# UNITED STATES PATENT AND TRADEMARK OFFICE

APPLICATION NO.	FILING DATE	FIRST NAMED INVENTOR	ATTORNEY DOCKET NO.	CONFIRMATION NO.
10/765,738	01/27/2004	James M. McDonough	APD-001	1102

<b>Office Action Summary</b>	<b>Application No.</b>	<b>Applicant(s)</b>	
	10/765,738	MCDONOUGH ET AL.	
	<b>Examiner</b>	<b>Art Unit</b>	
	Steven Wong	3711

FIG. 5.

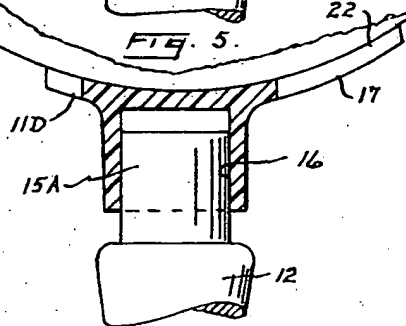
Regarding claim 11, the applicant argues that the golf ball shown in Figure 5 of Chase appears to contact more than just a portion of the legs. However, this is not persuasive as the leg members of Chase define multiple portions such as an end portion, a top portion and an underside portion. The golf ball as shown in Figure 5 only contacts the top portion of the leg members.
